Access Compliance Report

Public Rights-of-Way

(Curb Ramps)

Intersection ID: 50370	Main Street: GENEVIEVE_CT	Cross Street: COUNTRY_LN	Location: SE
ADA ID: 4A037F8DE4B1	Ramp Type: Perp	Initial Pass/Fail: Fail	Overall Compliance: No
Severity Score: 8.75			
Codes/Mitigation Info/Possible Solution		Field Measurements/Component Compliance

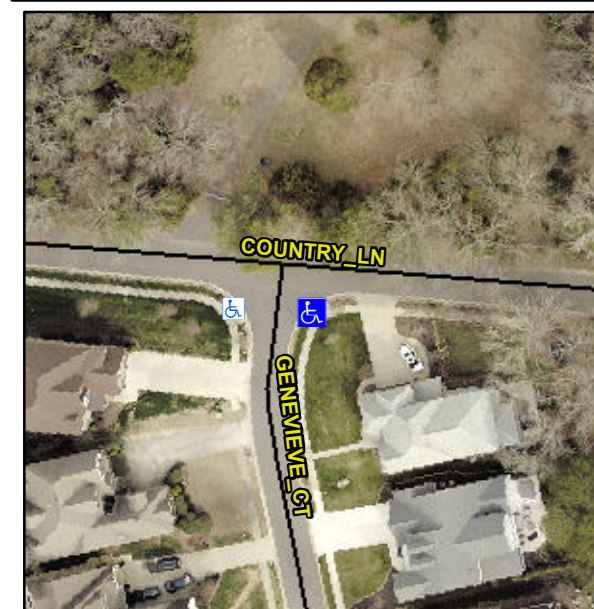
Not Found, R304.5.1

Compliance	Description	Data	Compliance	Description	Data
N/A	Ramp Length (in)	47.0	Yes	Ramp Slope (%)	7.0
No	Ramp Width (in)	45.5	Yes	Ramp XSlope (%)	1.8
N/A	Flare Type LT	N/A	N/A	Flare Type RT	N/A
N/A	Flare Slope LT (%)	N/A	N/A	Flare Slope RT (%)	N/A
N/A	Flare Traversable LT?	N/A	N/A	Flare Traversable RT?	N/A
N/A	Landing Length (in)	N/A	N/A	DWS Provided?	N/A
N/A	Landing Width (in)	N/A	N/A	DWS Contrast?	N/A
N/A	Landing Slope (%)	N/A	N/A	DWS Length (in)	N/A
N/A	Landing X Slope (%)	N/A	N/A	DWS Full Width?	N/A
N/A	Landing Curb? (Y/N)	N/A	N/A	DWS Offset (in)	N/A
N/A	Shared Landing?	N/A			
N/A	Gutter Ponding?	N/A	N/A	Gutter Slope (%)	N/A
N/A	Gutter Lip Ht (in)	N/A	N/A	Gutter X Slope (%)	N/A
N/A	Painted X Walk1?	No	N/A	Painted X Walk2?	N/A
	X Walk 1 Direction	To W		X Walk 2 Direction	N/A
N/A	X Walk 1 Width (in)	N/A	N/A	X Walk 2 Width (in)	N/A
	X Walk 1 Slope (%)	0.2		X Walk 2 Slope (%)	N/A
	X Walk 1 X Slope (%)	2.3		X Walk 2 X Slope (%)	N/A

Remove & Replace Entire Ramp.
